GENOA CHARTER TOWNSHIP BOARD

Regular Meeting

July 17, 2023

TO: Honorable Board of Trustees
FROM: Amy Ruthig, Planning Director
DATE: July 11, 2023
RE: Legacy Apartments - Dorr/Grand River Ave. Final RPUD PUD

NOT FOR CONSTRUCTION C-6.6

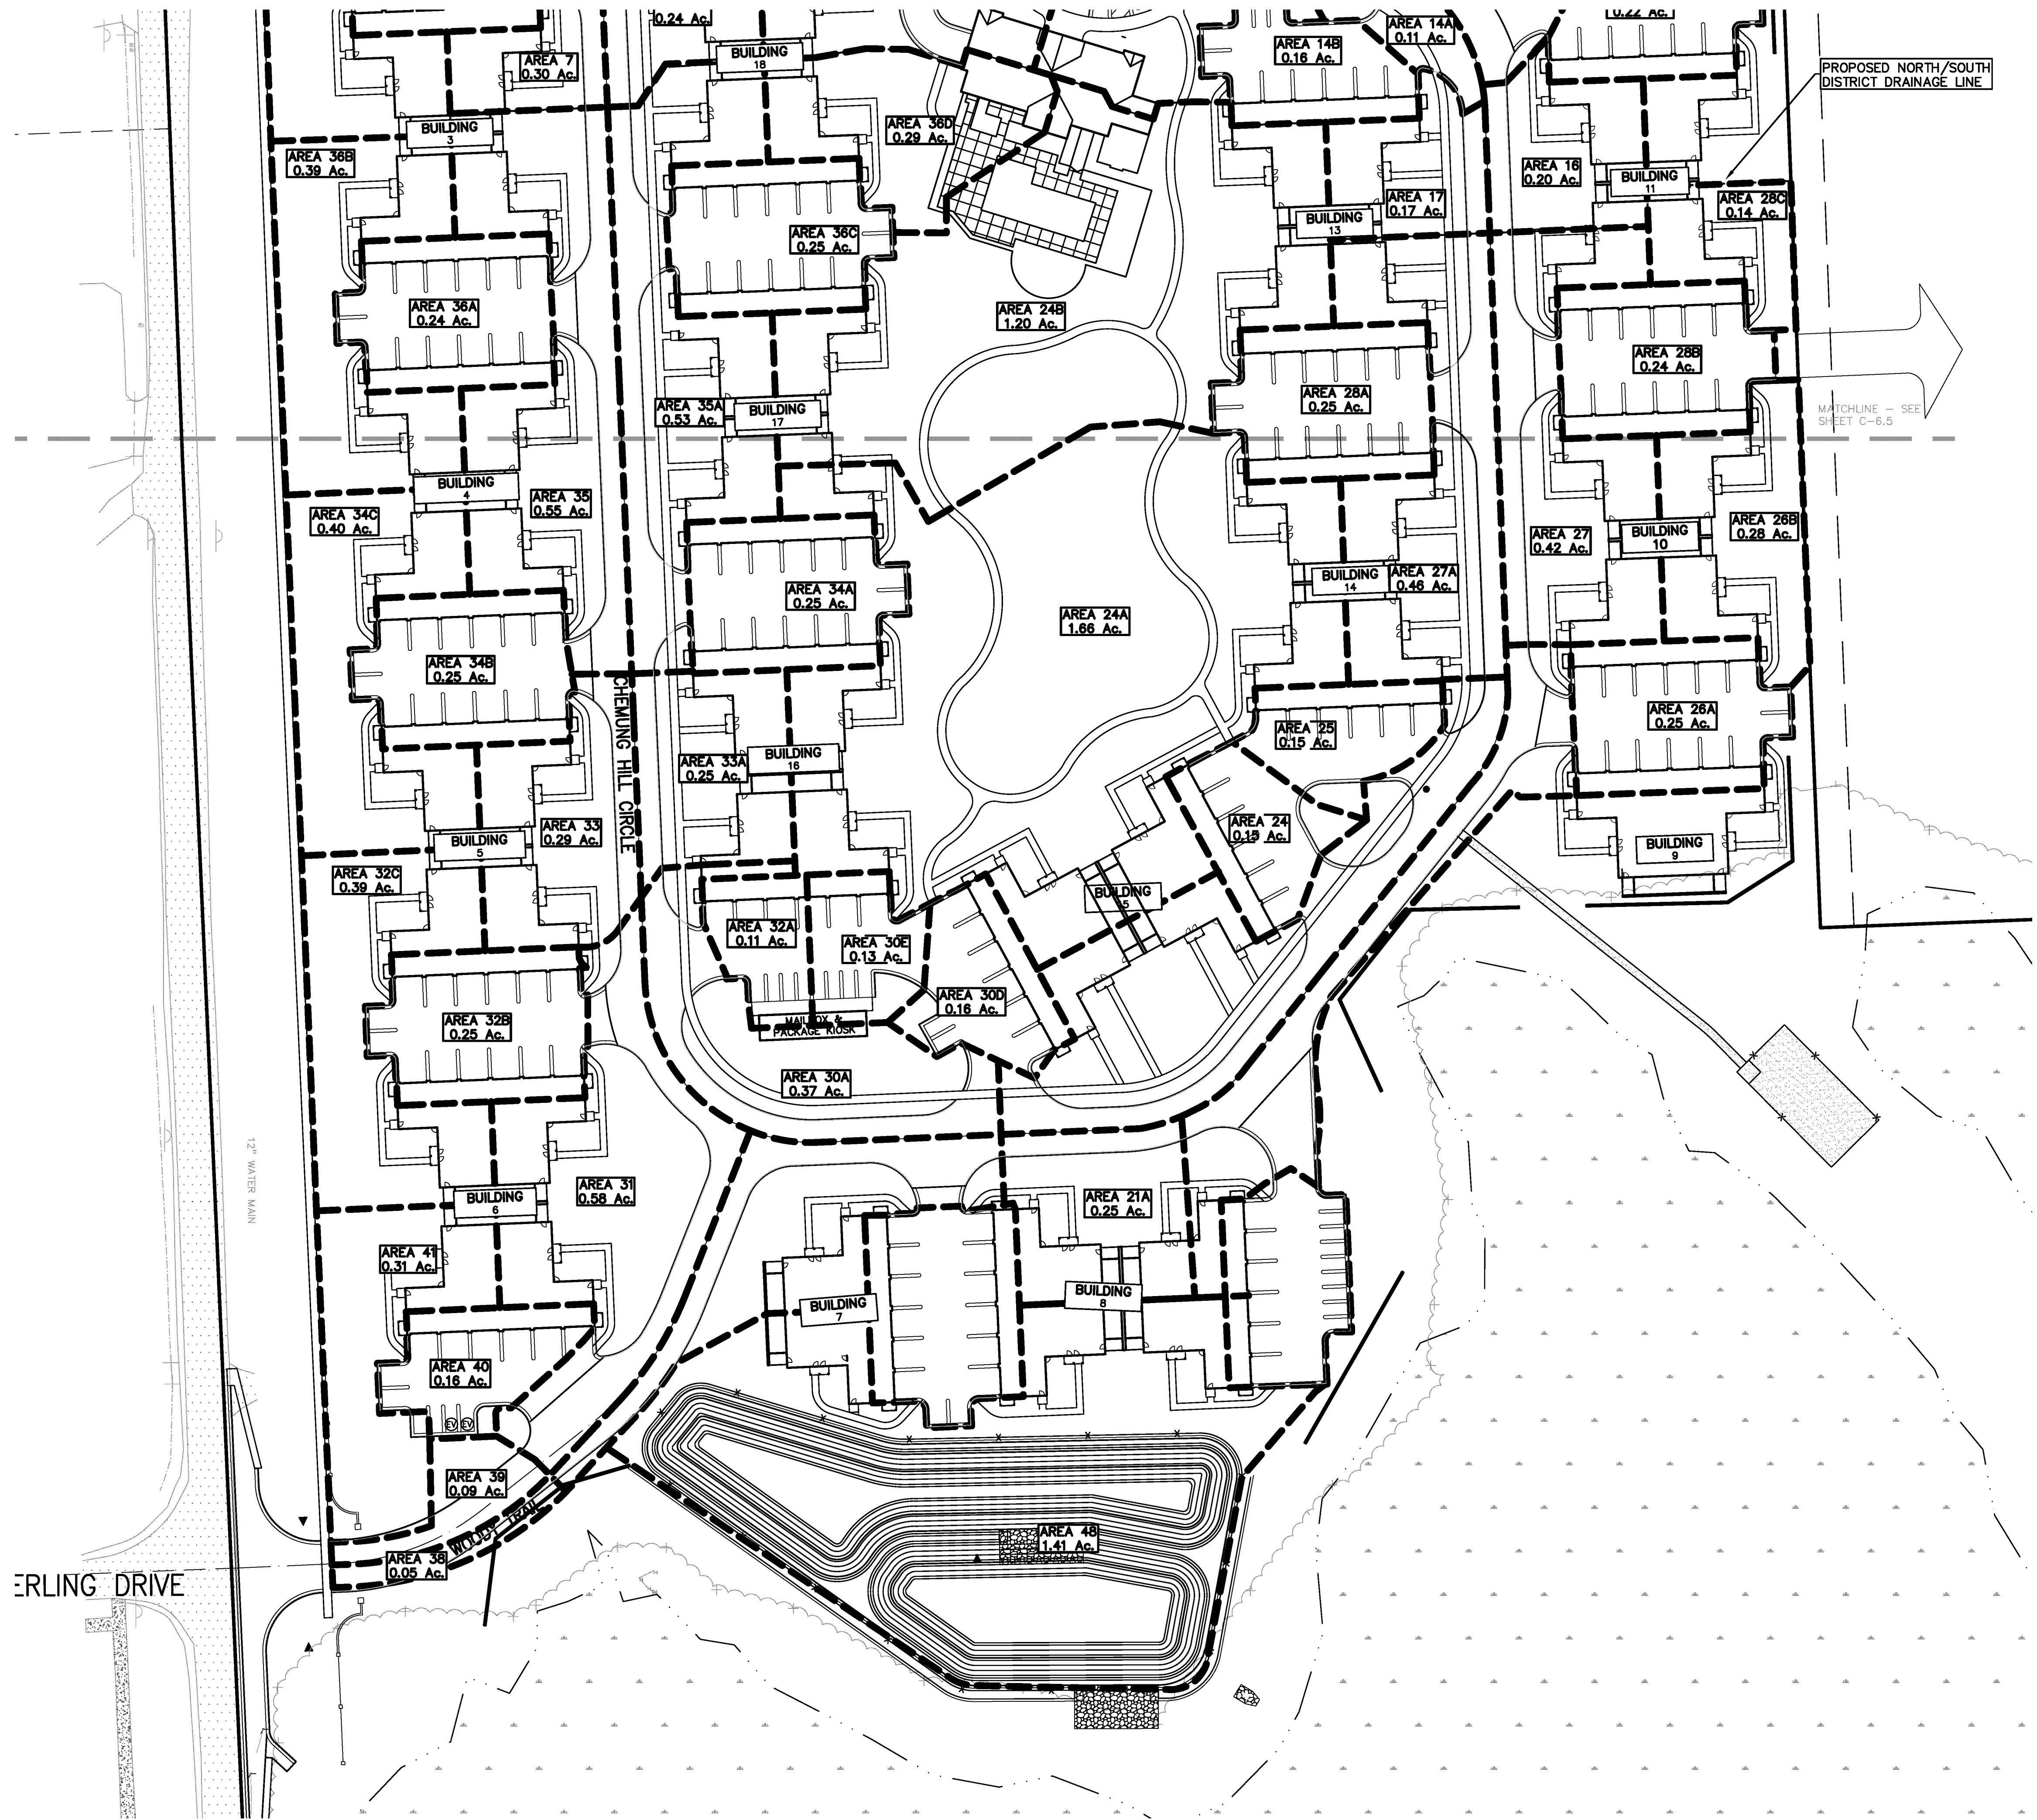
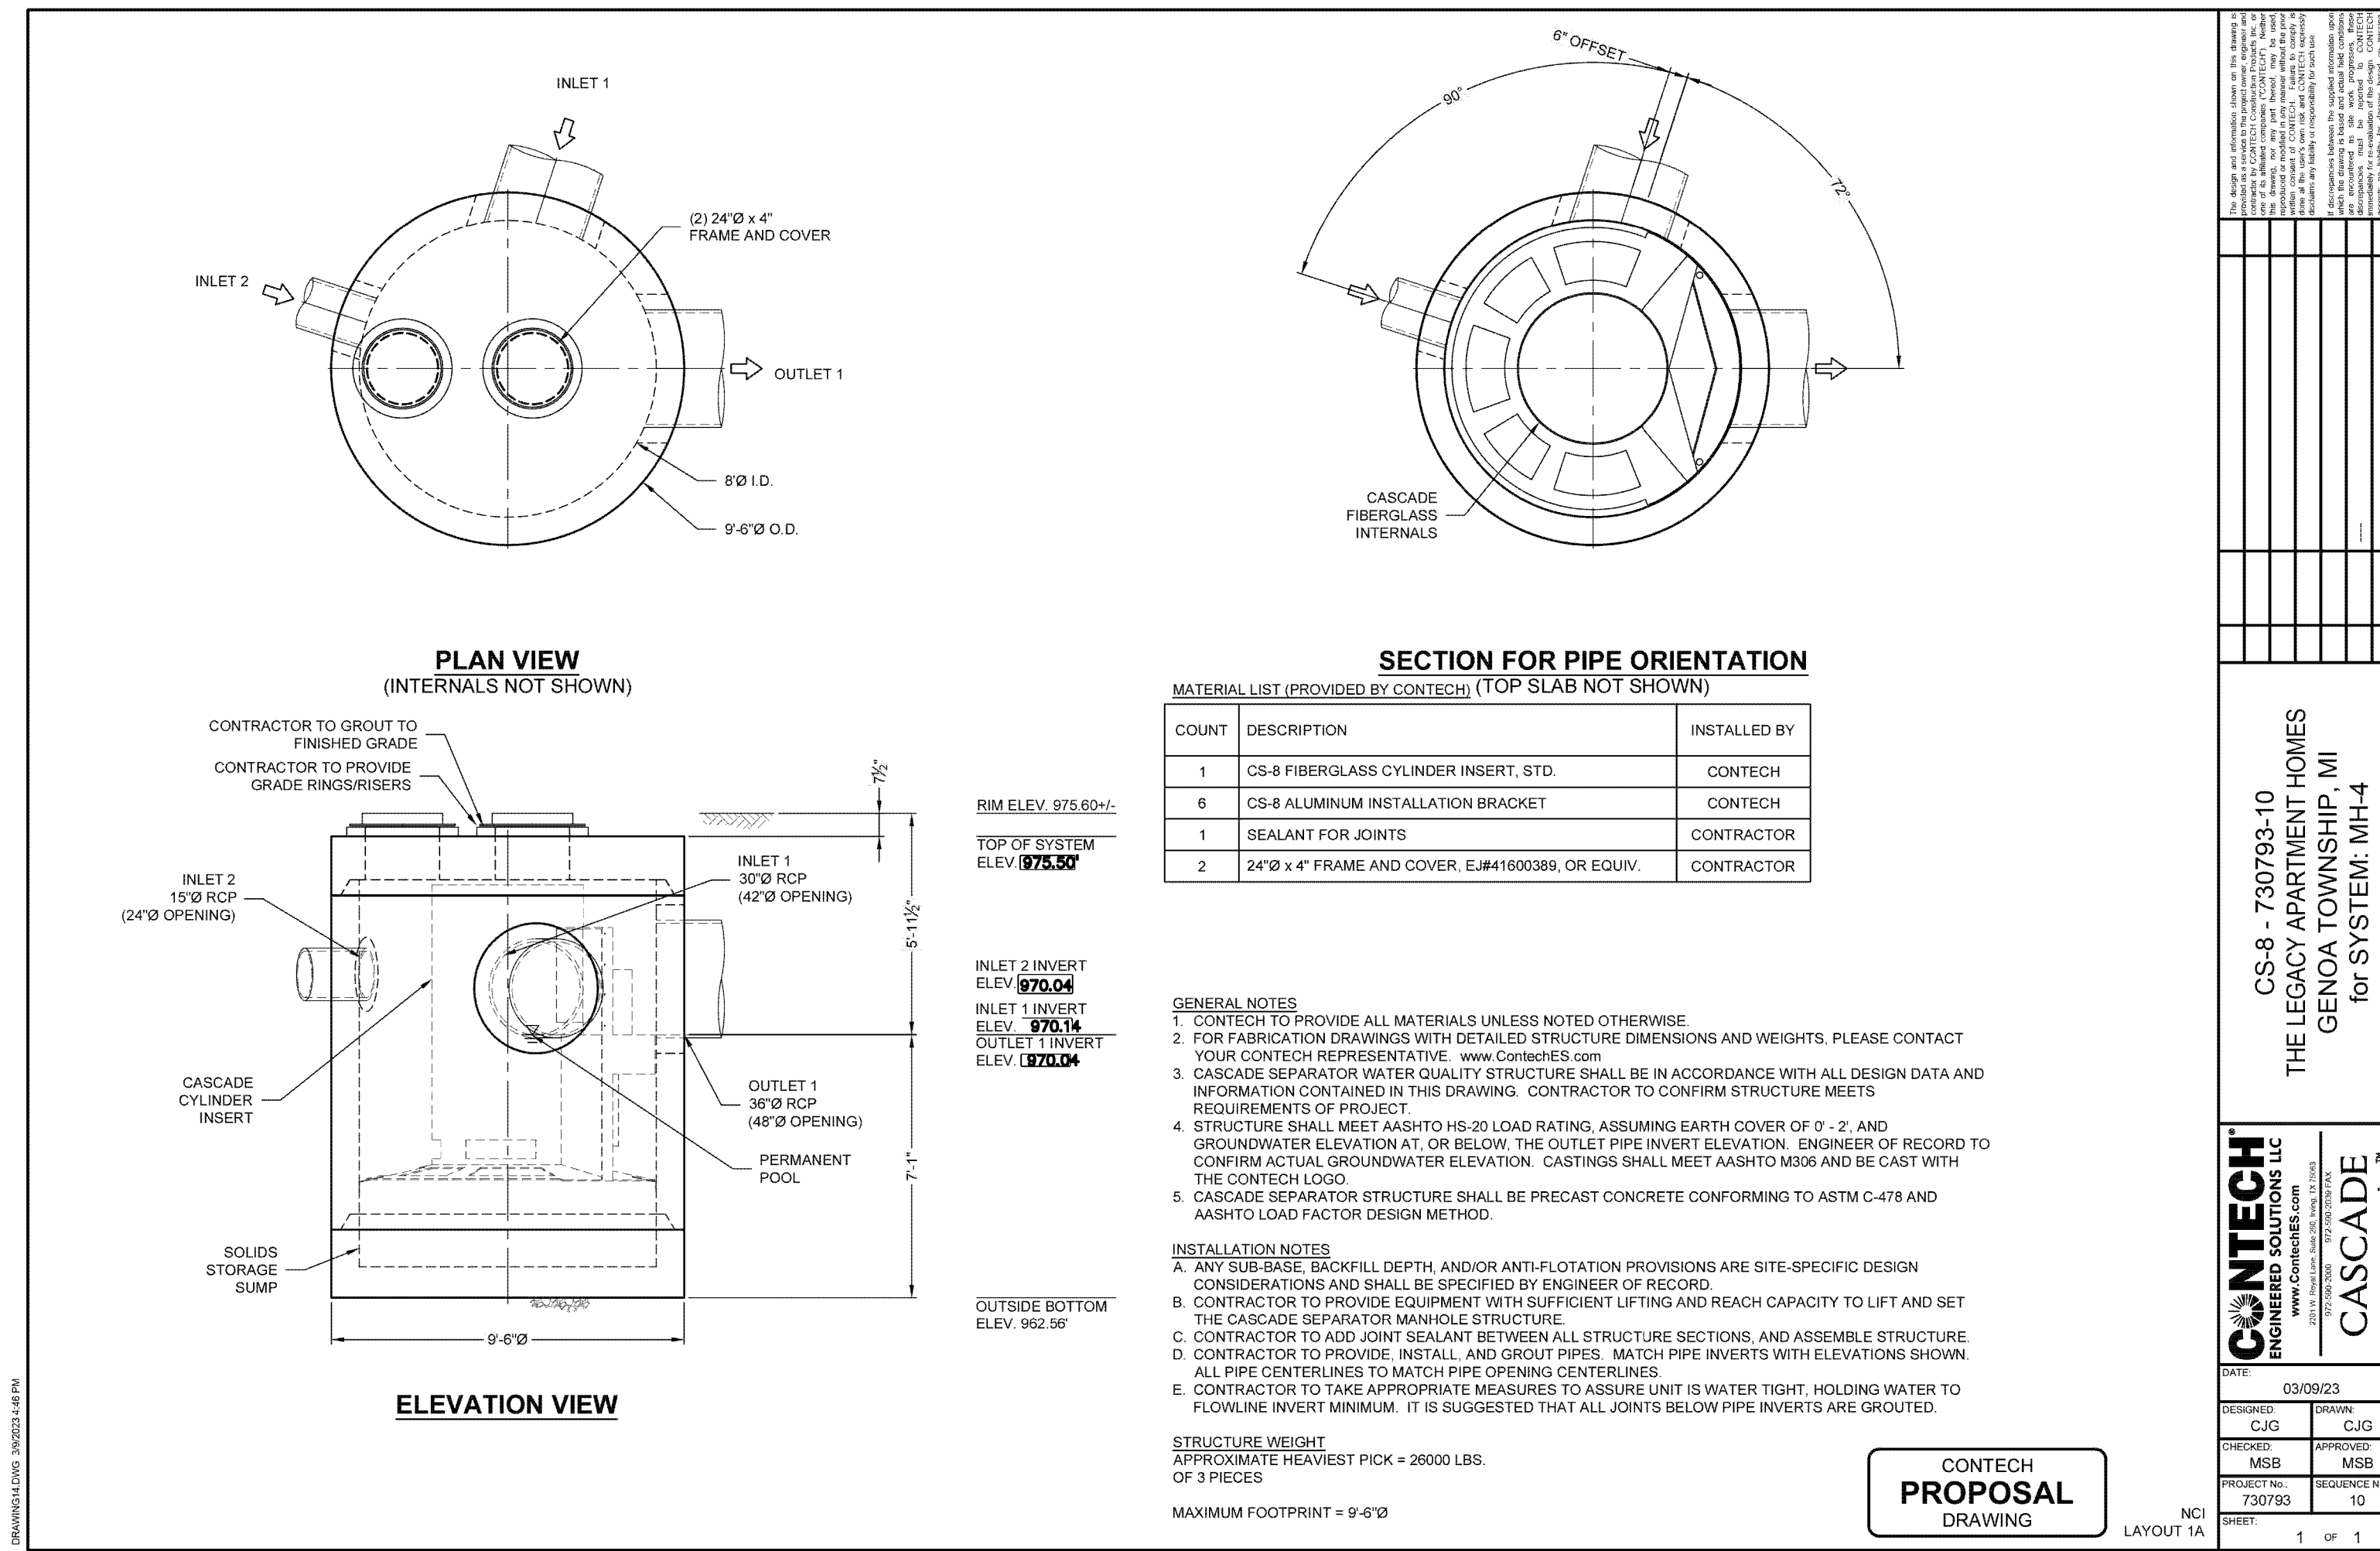
- 4.) Drainage Area Plans - Sheets C-6.5 and C-6.6 should show the drainage area boundaries and acreages of the tributary areas encompassing the North and South Detention Basins. It appears that part of the tributary area containing the South Basin has not been accounted for in its design. It also appears that the drainage boundary lines along Dorr Road should be shifted to its Master Planned Right-of-Way line and the scale noted on Sheet C-6.5 should be corrected.
